From: Amy Ball <aball@horsleywitten.com>
Sent: Thursday, September 03, 2015 9:14 AM
To: Jeffrey Ribeiro
Cc: Jonathon Idman; bill.richardson@jacobs.com; Magner, Maryann; Irvin.Baptiste@jacobs.com
Subject: Additional Materials Request #2
Attachments: NPS Signed Airport DRI submission 8-28-2015.pdf; 150428_GROUNDWATER MOUNDING CALC_4027_RACcheck.pdf; Sightseeing Shack photos of building materials_4027.pdf; CCNS Zoning Standards-2(1).pdf; 18July2014 RDA_PVC Floodlight Plans and Specifications (reduced file).pdf; WQC Mitigation Plan excerpt.pdf; bike path signage photos.pdf

Below is our response to your request for additional information on the Provincetown Airport DRI application.

Project Name: Provincetown Municipal Airport CIP Total Site Acreage: 331 ac
 Project/Property Location: 176 Race Point Rd Zoning: S State Class 9310

ELECTRICAL PLAN 1

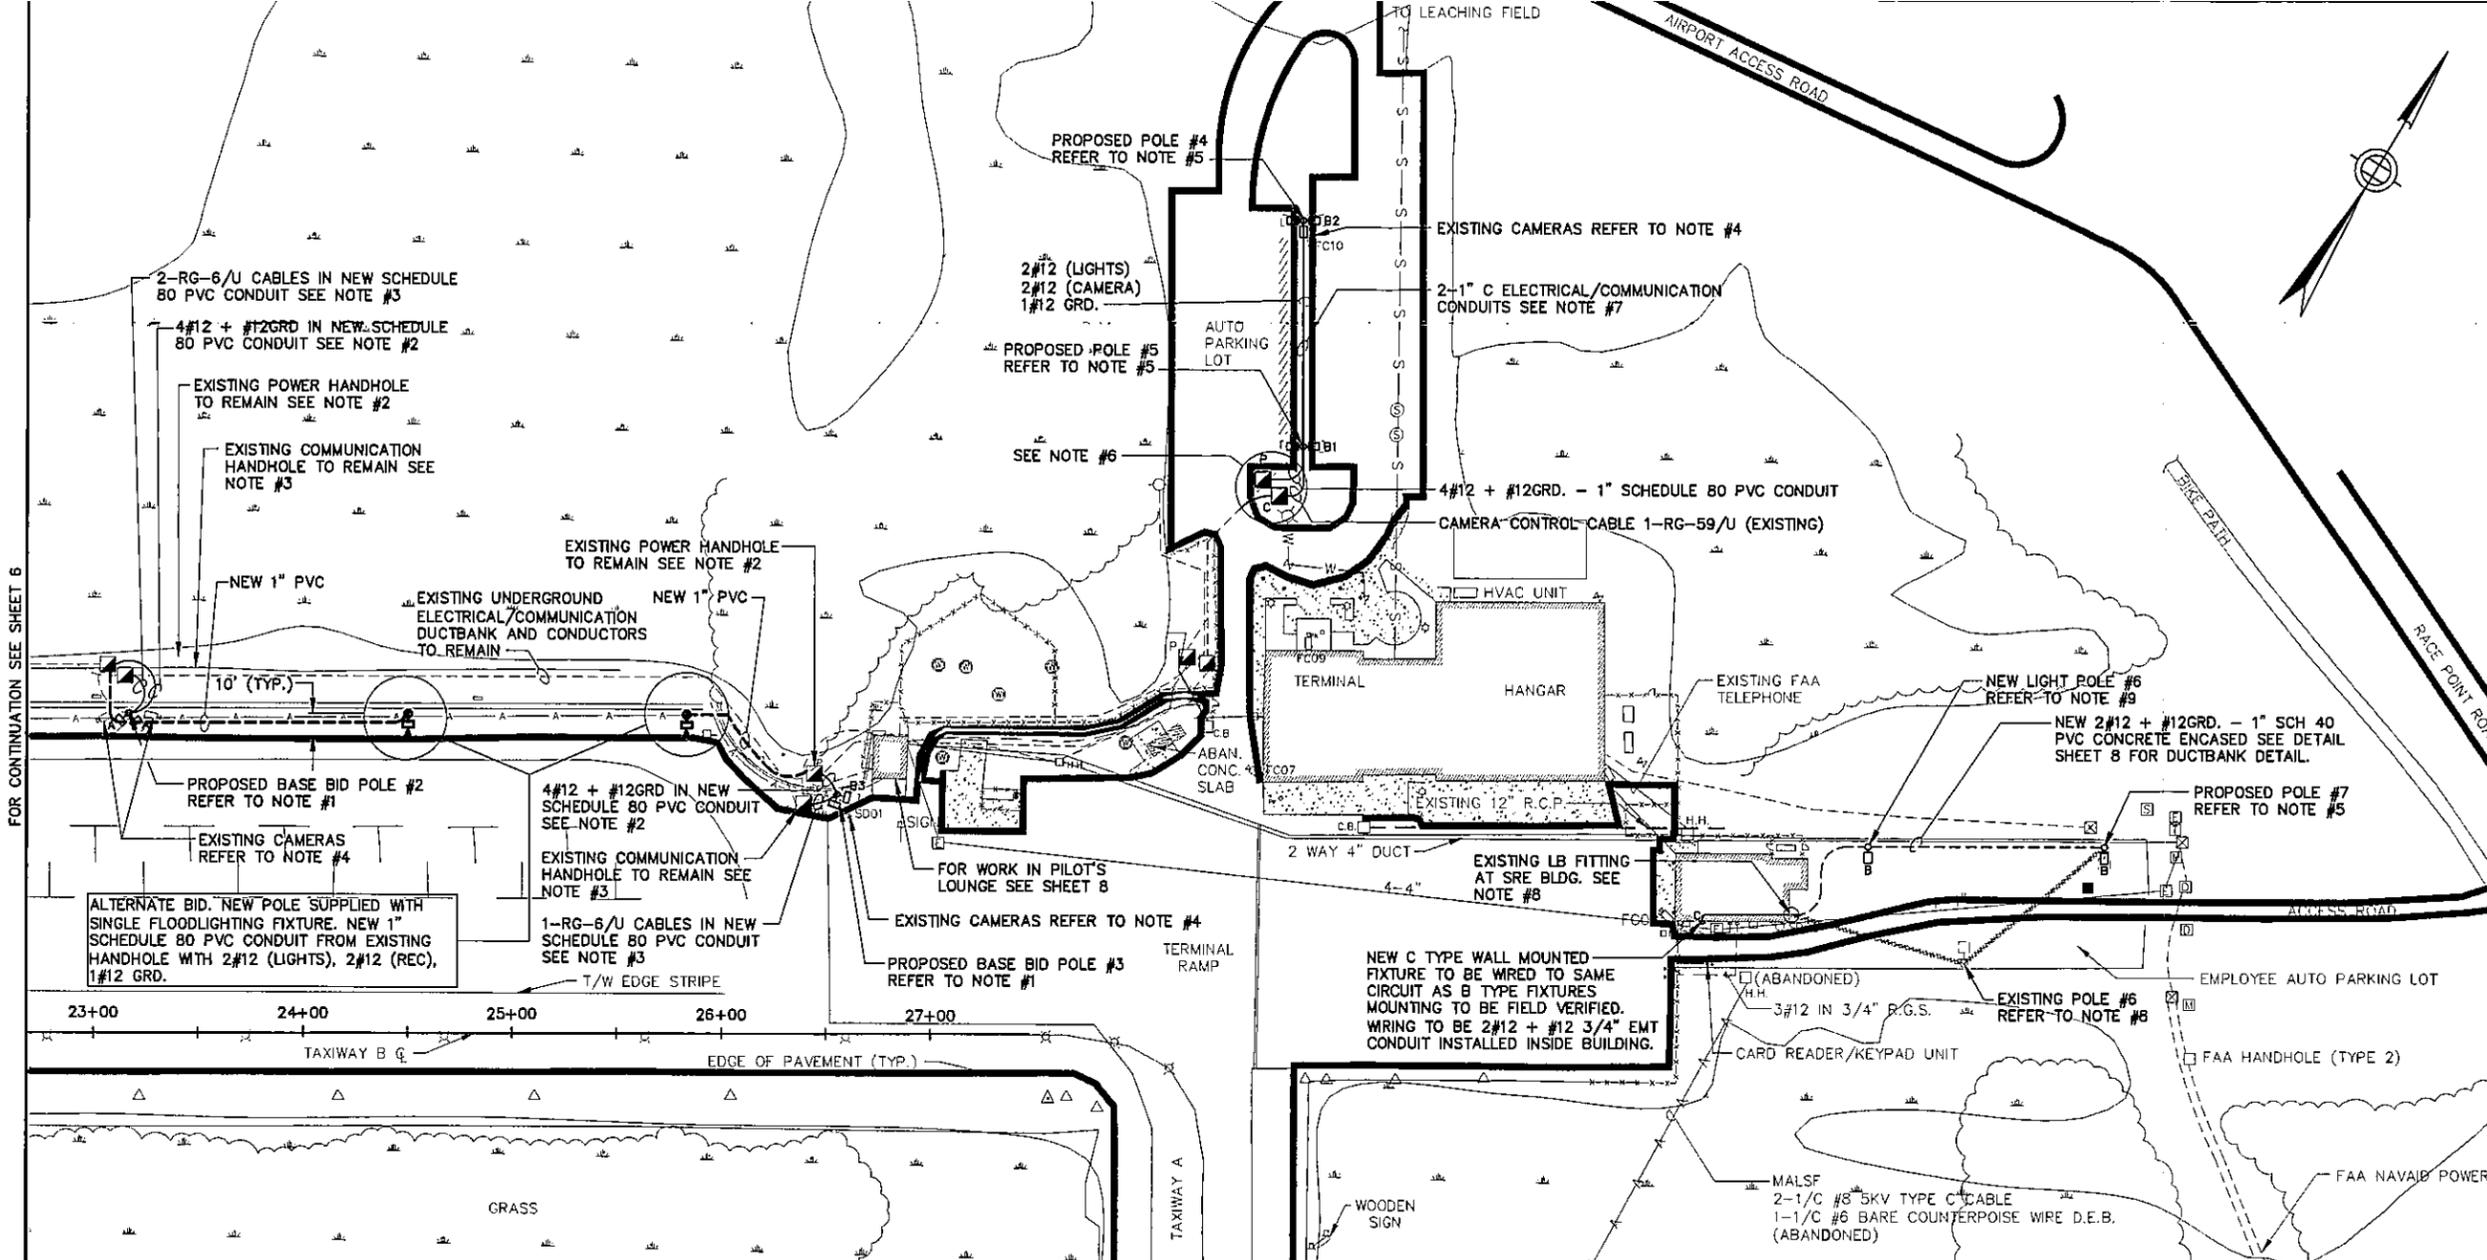
3. All lighting proposed aside from that required by the FAA must comply with MPS HPCC2.11. Fixture cut sheets and a lighting plan showing foot candle levels and fixture details must be provided. Further details on lighting requirements can be found in the RPP and in Technical Bulletin 95-001.
All lighting will be designed in accordance with the specifications within the RPP. The Airport permitted a lighting replacement project through the Provincetown Conservation Commission in 2014 with the specifications provided in the attached planset (18July2014_RDA_PVC_Floodlights Plans and Specifications) document (see pages 35, 36, and 37 of the PDF file). New lights proposed within the parking lot area will meet these same specifications.

MOUNDING CALCULATION
Permeable Pavement Area

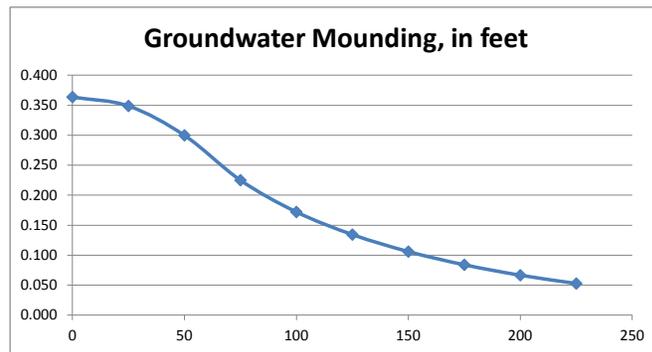
5. The Stormwater Checklist in the Stormwater Report indicates that separation to seasonal high groundwater beneath the porous pavement is less than 4 feet and a mounding analysis is provided as an appendix, but no appendix could be found. Please provide either the location of the appendix or the mounding analysis referenced.
The groundwater mounding calculations are attached. A maximum mound will occur at 0.364 ft above groundwater levels, which is well below the 2' required groundwater separation distance, so there is no possibility for breakout. Using a Sandy Loam soil with an infiltration rate of 1.05"/hr (0.087 ft/hr), the mound will drawdown in 4.16 hours (0.364 ft/0.087ft/hr), well below the 3 day required drawdown rate.

Inputs for the groundwater mounding analysis included:

R: Recharge over the entire porous pavement area (6,988 sq ft) = 4.8" (the precipitation of the 10 year storm) = 0.40 ft/day

Sy: Specific yield = 0.1; very conservative for sandy loam materials (0.1 is typical for till or peat), so conservative.

K: Horizontal hydraulic conductivity = 50 ft/day; very conservative for sandy loam materials.

x: ½ the length of the basin (calculated from total surface area/width = (6,988 sf/60 ft) = 116.5 ft/2 = 58.2 ft.

y: ½ the width of the basin = 60/2 = 30 ft.

t: duration of the infiltration period = 24 hour rainfall event = 1 day.

Hi(0): initial thickness of the saturated zone = 50 ft = very conservative for a groundwater elevation at 6 ft above sea level.

Distant view (facing east) of existing bikepath crossing approaching Airport Road. The car to the right is entering Airport Road. Existing signage and markings will be maintained.

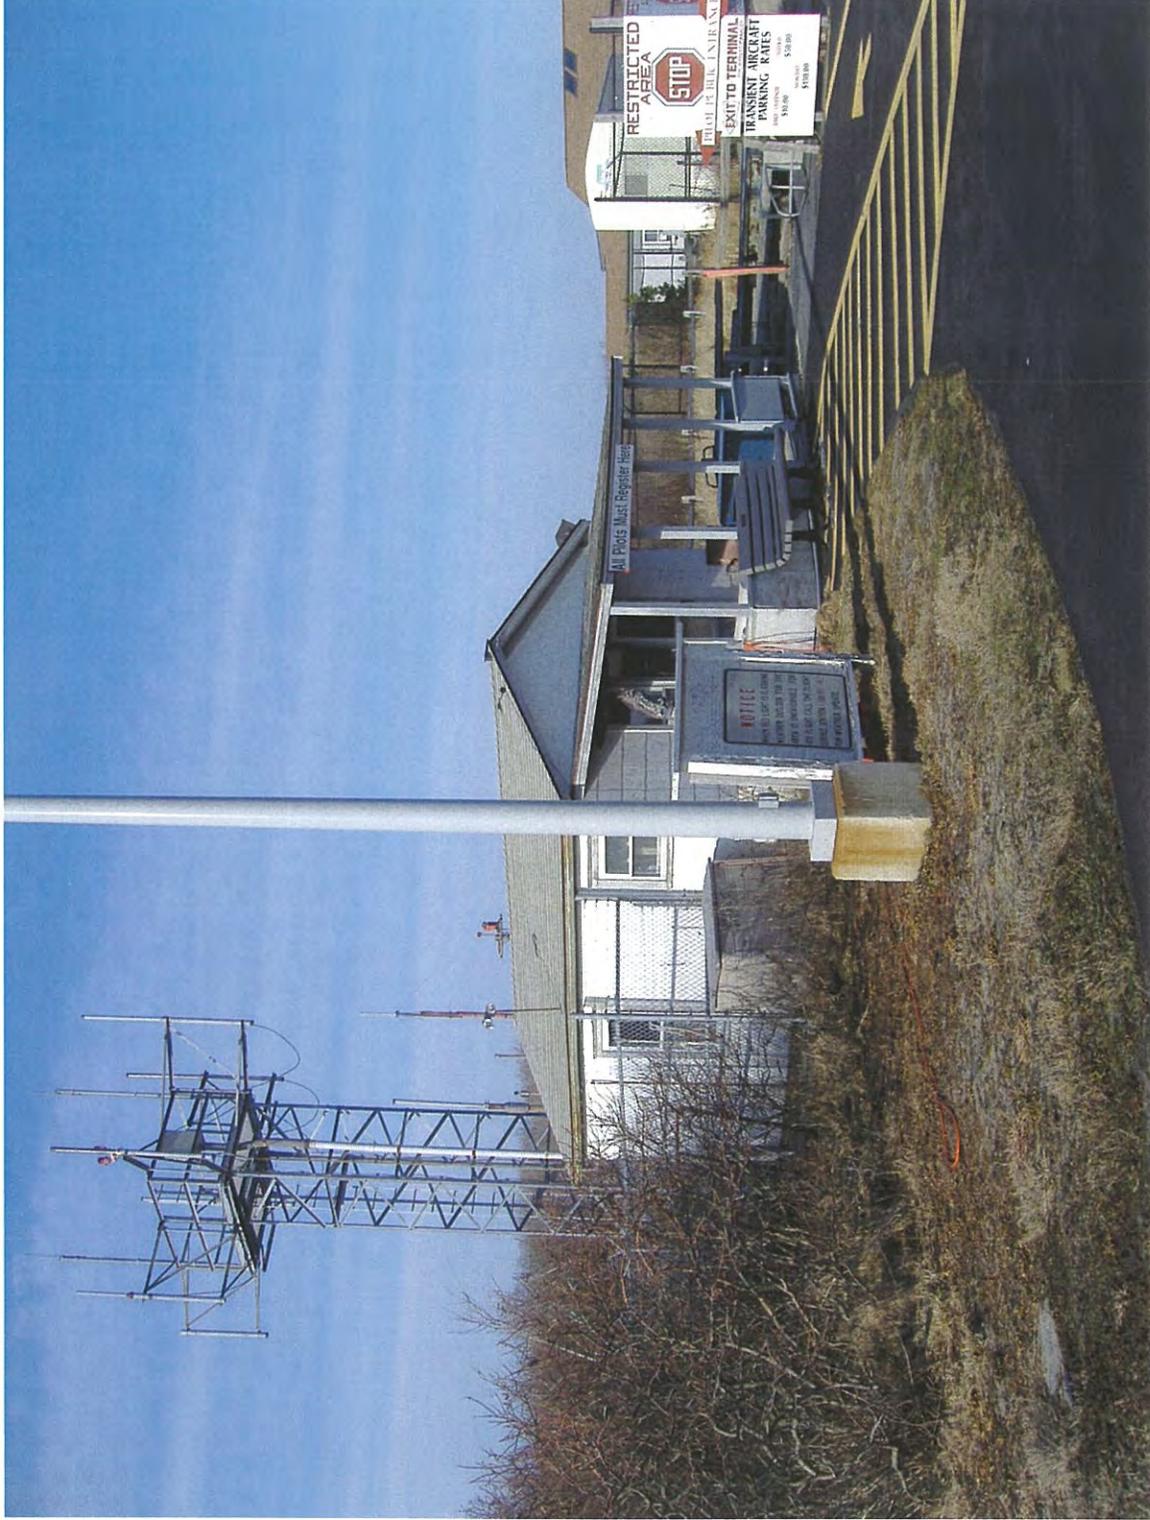
1. The MPS consistency chart discusses bike signage in reference to MPS TR1.7. Staff could not identify such signage on the plans provided. Further clarification would be appreciated.
[Existing bike path signage will be maintained. Photos of the signage and pavement markings across Airport Road \(as shown on the plans, Sheet 9\) are attached.](#)

View (facing east) of existing bikepath crossing of Airport Road. The intent is to maintain (or replace if necessary), existing signage and pavement markings to ensure the safety of bikepath users and Airport users.
